## **MINUTES OF THE 63<sup>rd</sup> MEETING OF THE RE-CONSTITUTED EXPERT APPRAISAL COMMITTEE (EAC) ON ENVIRONMENTAL IMPACT ASSESSMENT (EIA) OF THERMAL POWER & COAL MINING PROJECTS**

The 63<sup>rd</sup> Meeting of the reconstituted EAC (Thermal Power) was held on 29<sup>th</sup> & 30<sup>th</sup> August, 2016 in the Ministry of Environment, Forest & Climate Change at Teesta Meeting Hall, Vayu Wing, First Floor, Indira Paryavaran Bhawan, Jorbagh Road, New Delhi. The following members were present:

#### **2.1 Setting up of 2x660 MW Coal Based Thermal Power Project near village Malwan, District Etah, Uttar Pradesh by M/s Jawaharpur Vidyut Utpadan Nigam Ltd (JVUNL) –regarding EC**

**REPORT ON THE SPOT INSPECTION OF THE PROJECT SITE  
OF 4×270 MW BHADRADRI THERMAL POWER PLANT OF  
M/S TELANGANA STATE POWER GENERATION  
CORPORATION LIMITED (TSGENCO) (M/S BHADRADRI  
THERMAL POWER STATION) AT RAMANUJAVARAM,  
EDULLABAYYARAM AND SEETHARAMPURAM VILLAGES  
OF MANUGURU AND PINAPAKA MANDALS, KHAMMAM  
DISTRICT, TELANGANA**

- The Plot plan showing the proposed diversion of drain from main road (Manuguru - Etrurunagaram) to natural drain (maddhula vagu) is enclosed.

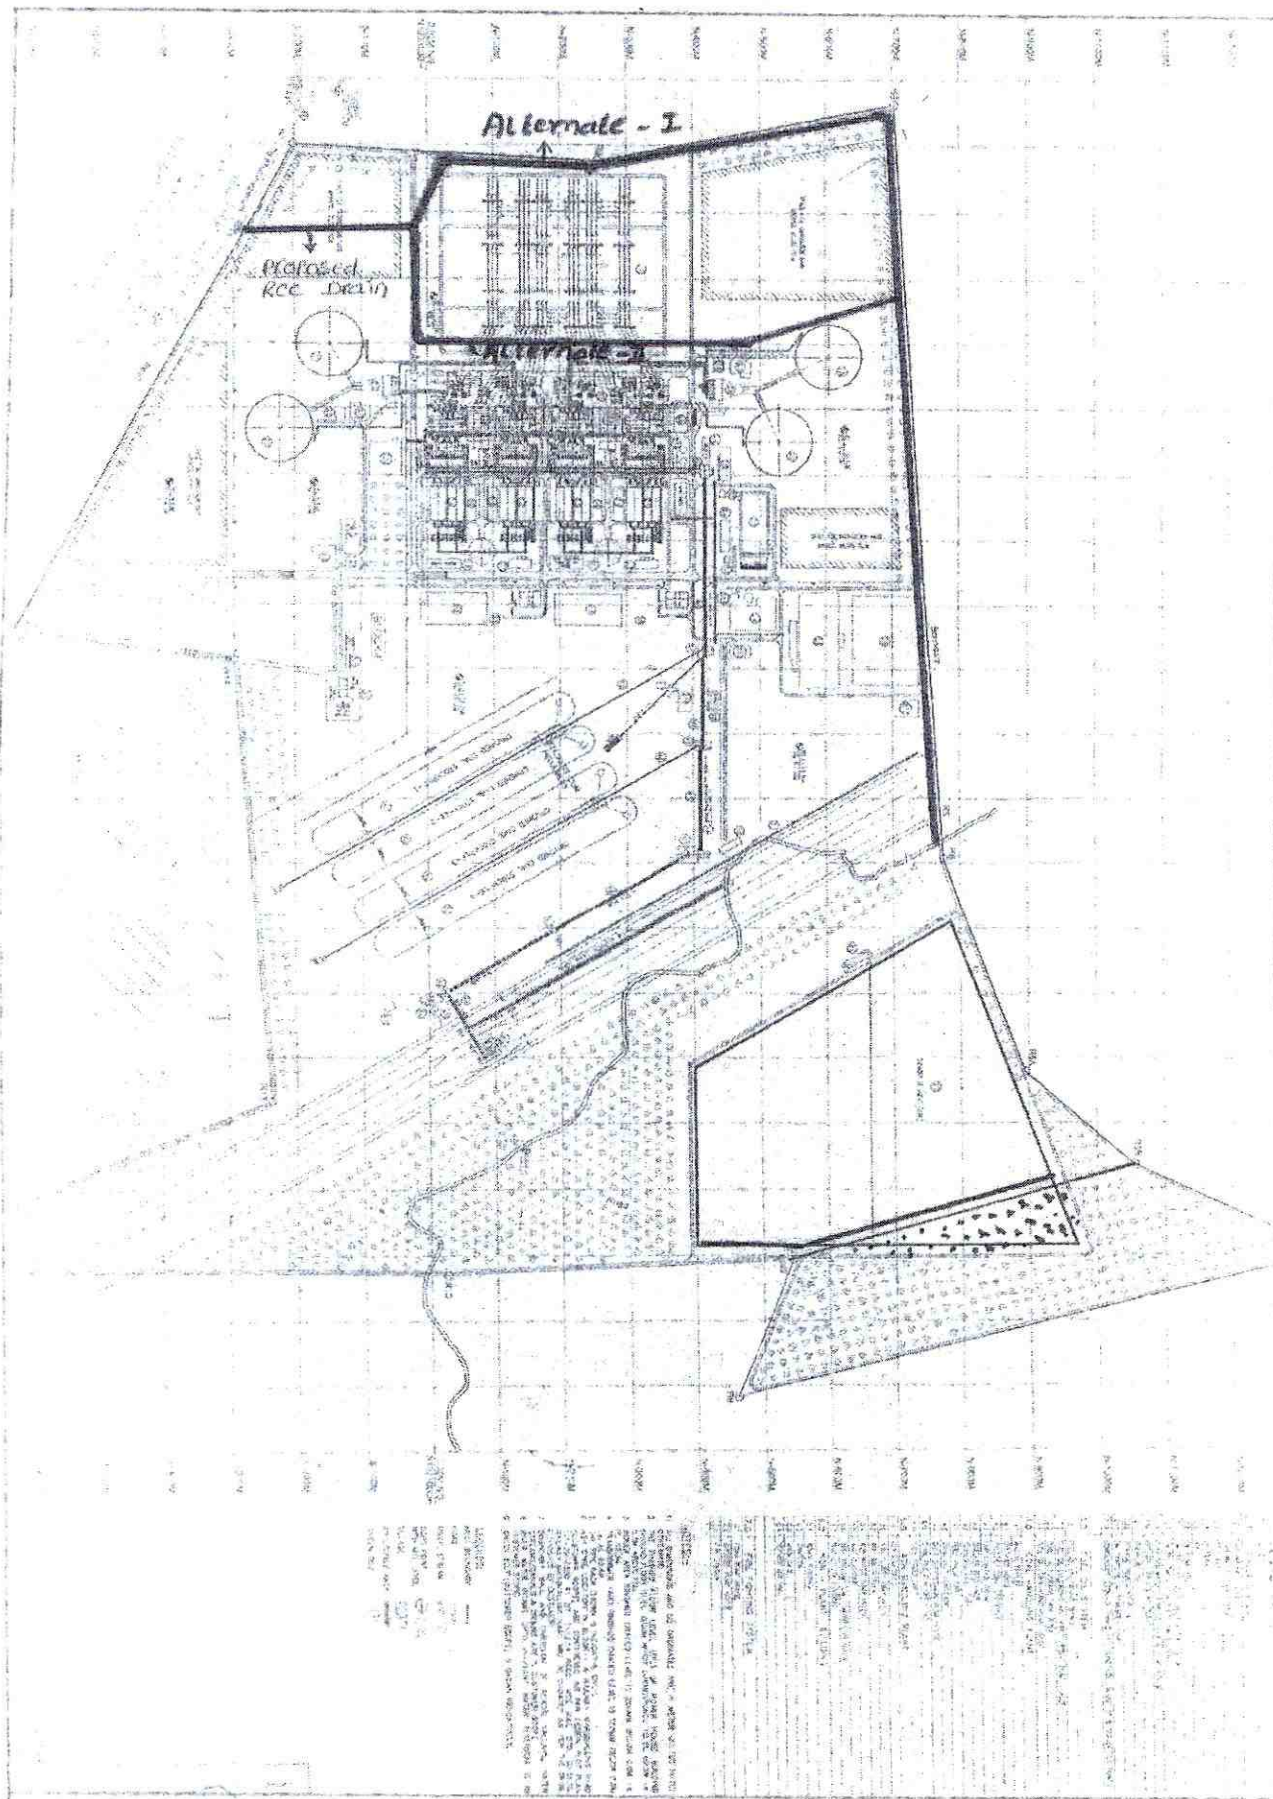
(iv) The earthworks carried out in the Block I did not impact the two major nallahs (streams of 3<sup>rd</sup> order) that runs through the project area, but disrupted abandoned irrigational canals and 1<sup>st</sup> and 2<sup>nd</sup> order drainage channels. Only one 2<sup>nd</sup> order channel was disrupted due to earthwork in Block I (**Figure 4**). This can be diverted to the periphery of the project area with its natural gradient. The storm drainage of the plant area is yet to be designed and this is possible only after levelling and grading of the area. In light of above, there is no impediment in the appraisal process of impacts on the natural drainage. However, the PP can provide the design for the diversion of this channel at the time of appraisal of EIA.

**Figure 3: Map showing the project area and its three blocks.**

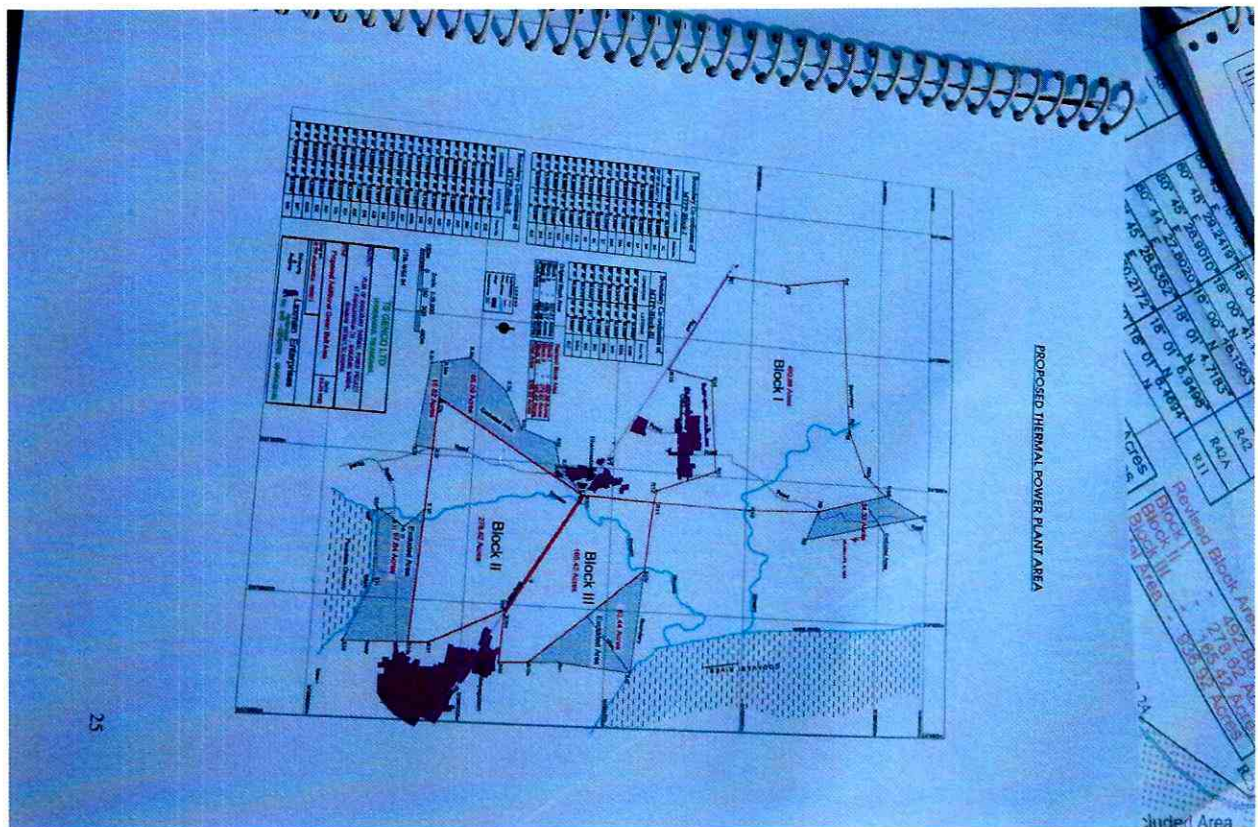
the East after passing along the Perantala Cheruvu and also along a narrow deep depression (small waterbody) located to the North of Perantala Cheruvu (**Figure 3**).

**Figure 4: Contour maps showing the 2<sup>nd</sup> and 3<sup>rd</sup> order channels (streams) passing through the Block I of the project site.**

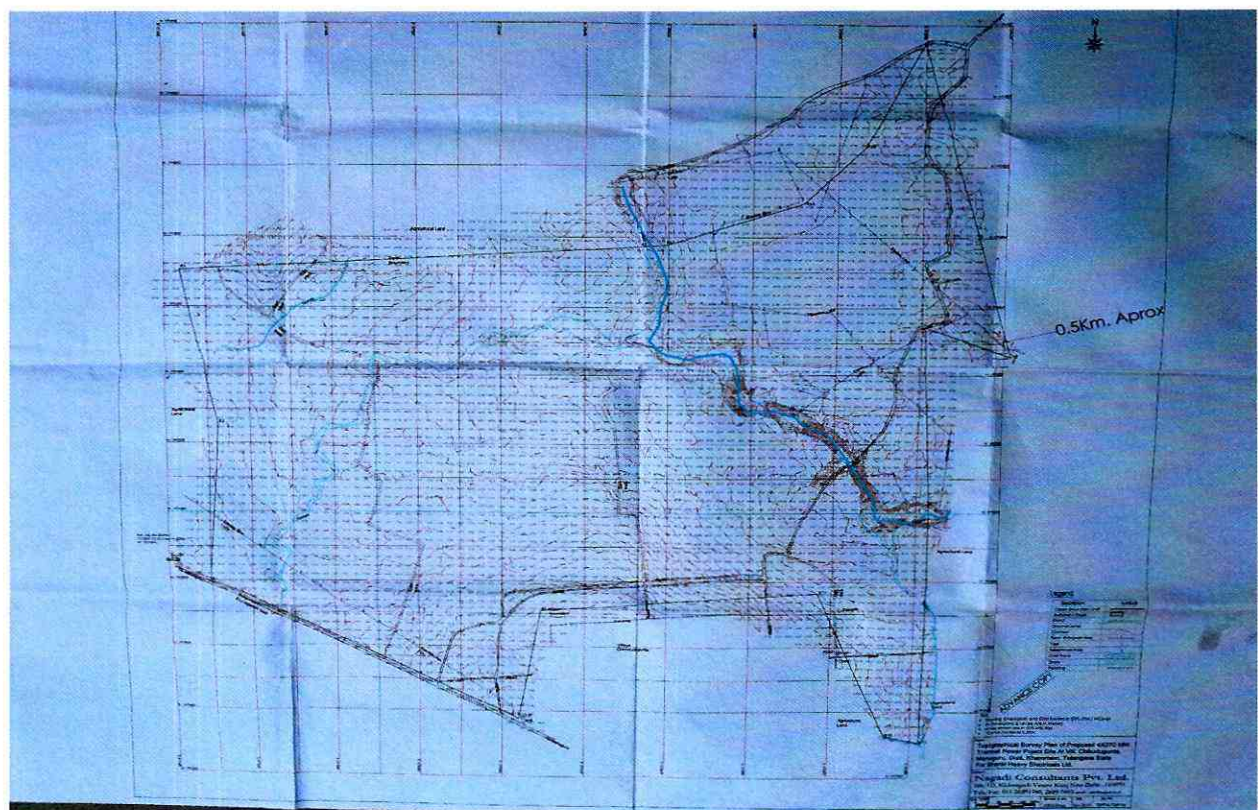
(iii) There are 1<sup>st</sup> and 2<sup>nd</sup> order drainage channels and these essentially drain the project area and paddy fields during monsoon into 3<sup>rd</sup> order stream which discharge its contents into Godavari. Small irrigation canals originating from large waterbodies, besides surface drainage channels also drains the excess water from large waterbodies and paddy fields into 2<sup>nd</sup> and 3<sup>rd</sup> order channels (**Figure 4 & 5**).

**Figure 7: Block II (ash dyke area) showing the unaltered landscape with a small waterbody and 3<sup>rd</sup> order stream passing through the area.**

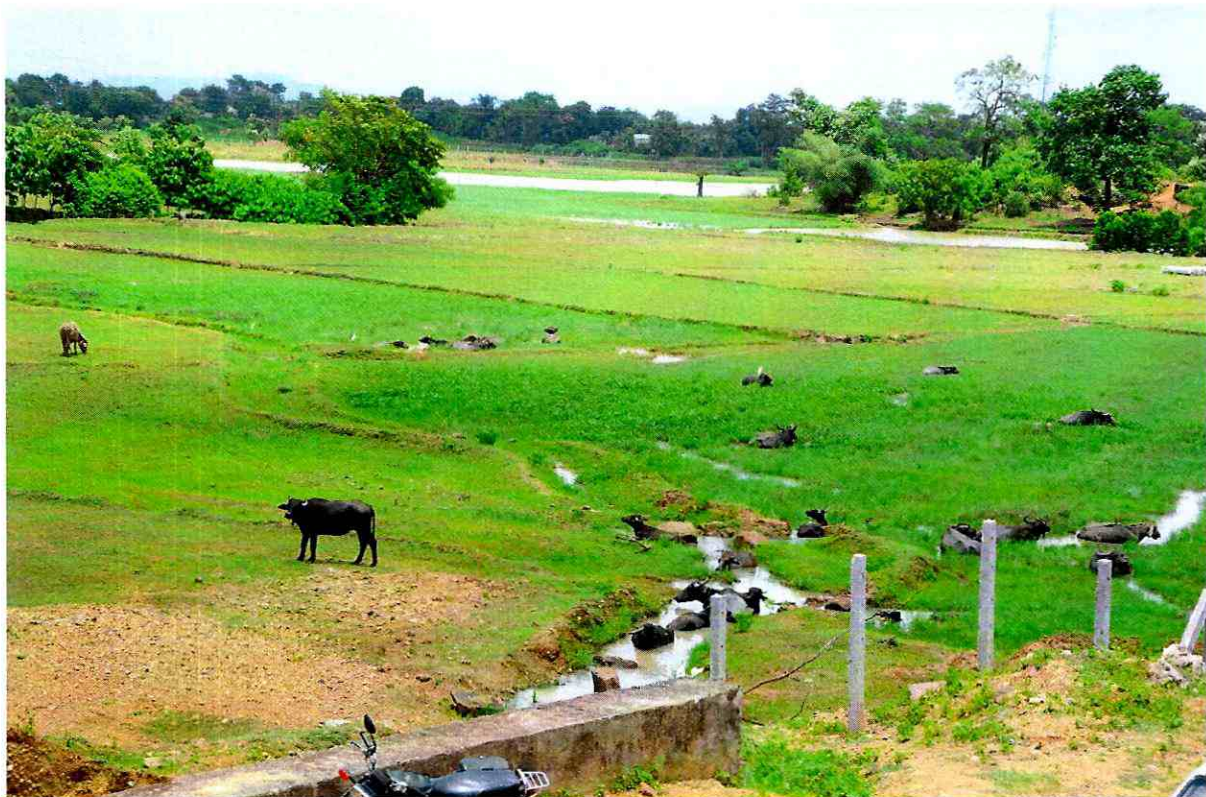
In the entire Block II (ash dyke area of 250 acres), no activity was carried out; (**Figure 7**). The township area of 50 acres was provided to Bharat Heavy Electricals Limited (BHEL) for storage of materials and machinery; no earth work was carried out in the area (**Figure 8**) but erected two temporary sheds for storage of sensitive equipments.

(ii) The entire Block II (ash dyke area) of 250 acres was unaltered, i.e. no activity including construction of boundary was undertaken (**Figure 7**) and hence no impediment on the appraisal process of the environmental impacts.
